**Planning & Development Division**  
*Planning & Economic Development Department*

<b>File Number</b>	PL 22-122	<b>Contact</b>	Chris Lee, <a href="mailto:clee@duluthmn.gov">clee@duluthmn.gov</a>	
<b>Type</b>	MU-I Planning Review: Accessory Parking Lot	<b>Planning Commission Date</b>		August 9, 2022
<b>Deadline for Action</b>	<b>Application Date</b>	July 6, 2022	<b>60 Days</b>	September 4, 2022
	<b>Date Extension Letter Mailed</b>	July 15, 2022	<b>120 Days</b>	November 2, 2022
<b>Location of Subject</b>	916 East 3 <sup>rd</sup> Street			
<b>Applicant</b>	Jefferson School, LLC	<b>Contact</b>	Christian Murphy	
<b>Agent</b>	Northland Consulting Engineers	<b>Contact</b>		
<b>Legal Description</b>	See attached, PIN: 010-3830-07680, 010-3830-07692			
<b>Site Visit Date</b>	July 25, 2022	<b>Sign Notice Date</b>		July 26, 2022
<b>Neighbor Letter Date</b>	July 26, 2022	<b>Number of Letters Sent</b>		63

**Proposal**

revision	
Proj: 18-221	Date: XX/XX/XX
Drawn: PMR	Checked: TPD
SITE GRADING AND UTILITIES	
Sheet Title	
Sheet Number	
<b>C5.0</b>

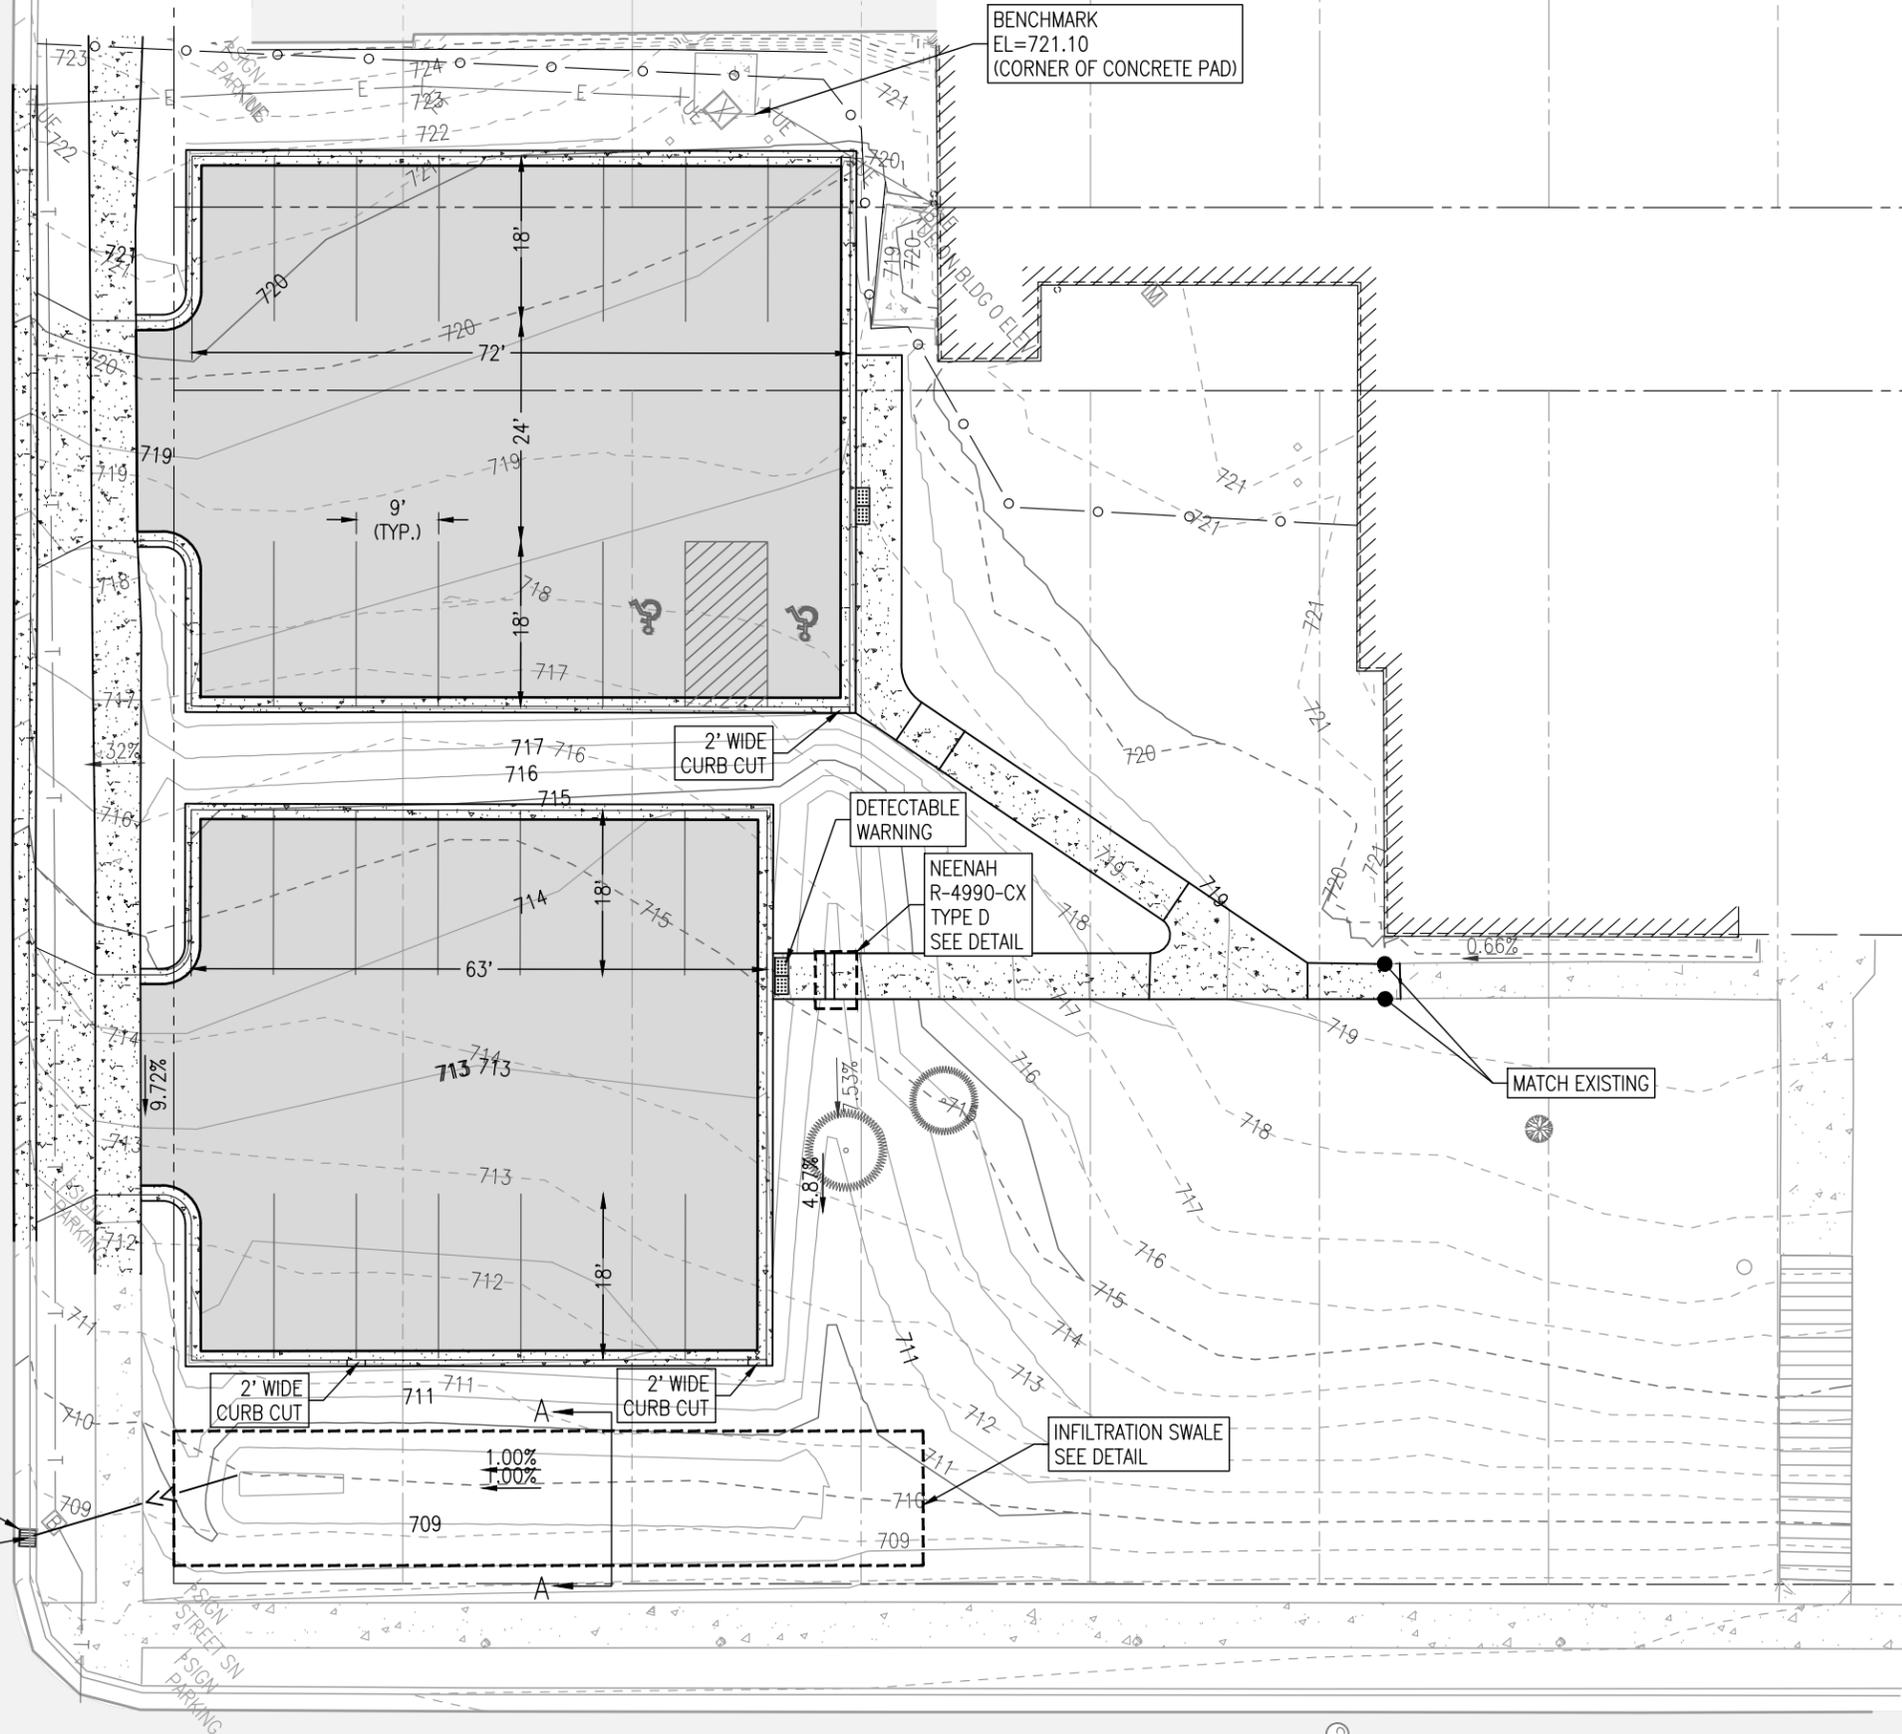
- 2) 50-18.1 (Stormwater Management) – The applicant will be required to submit a stormwater plan for review by the City's Engineering Department prior building permits approved. The applicant has proposed a swale for catching and filtering stormwater runoff for the new lots. This swale is located on the south corner of the property.
